51 – 52 Tottenham Court Road  
London W1T 2EH

Basement Impact Assessment  
Audit

For  
London Borough of Camden

Revision: F1

## INDICATIVE PROPPING DIAGRAM FOR UNDERPINS (PARTY WALL NO. 53)

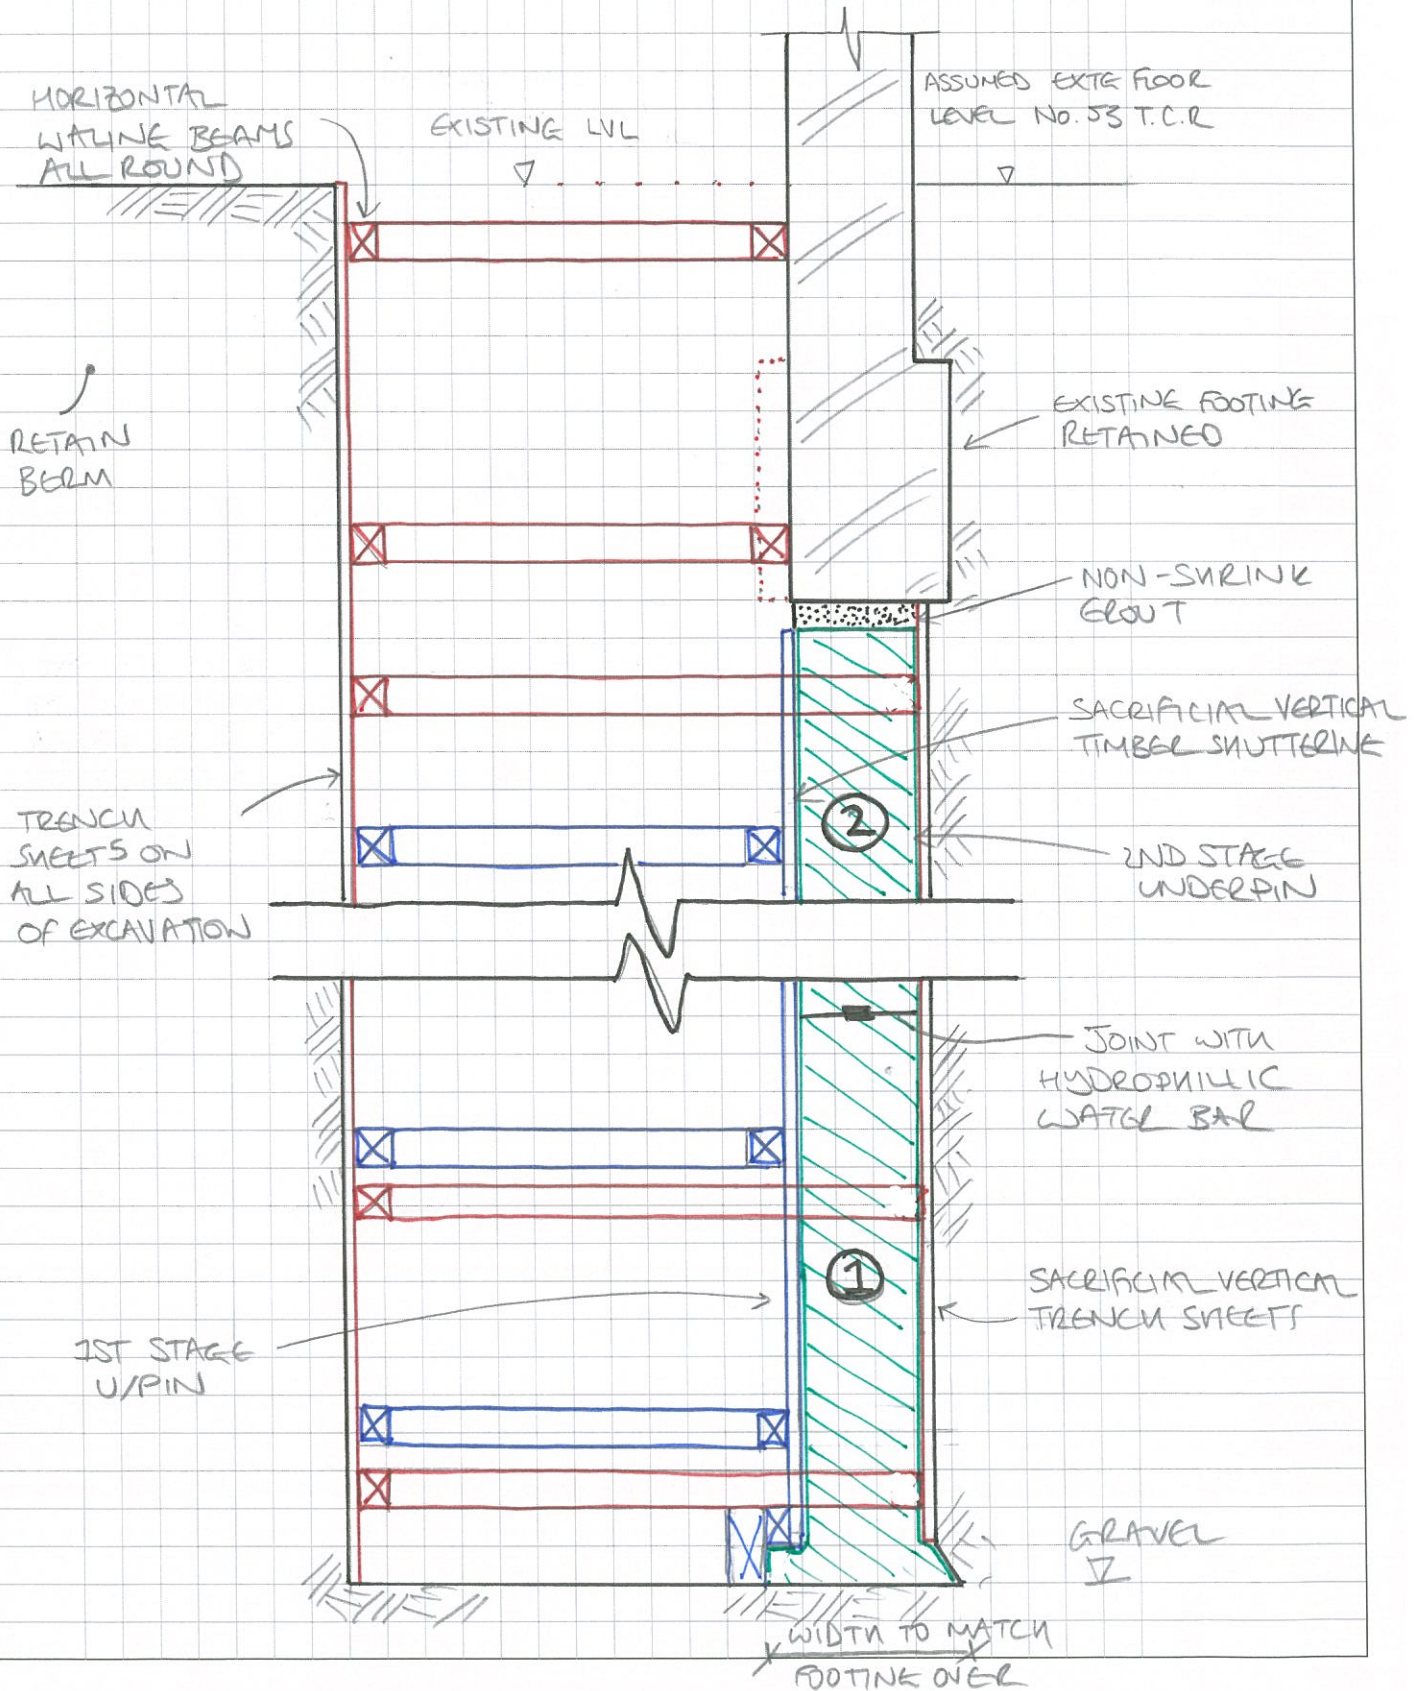
Thank you for the revised information and discussion this morning. With regards the construction sequence, could you also add a couple of section sketches please so we can understand the proposed propping arrangements?

Please find attached our indicative propping arrangement for installation of the mass concrete underpins beneath the Party Wall to No. 53 T.C.R. A similar arrangement can be adopted for casting the r.c. pins that will become integral with the piled raft.

Note that for all underpins shown in green on the previously issued mark-up (re-attached for information), packing between the r.c. and masonry wall over will not be installed until a continuous beam has been formed between pins to transfer loads down to the piles. As noted, in the temporary case a Pynford beam will be installed spanning between the underpins in Pink, supporting structure over.
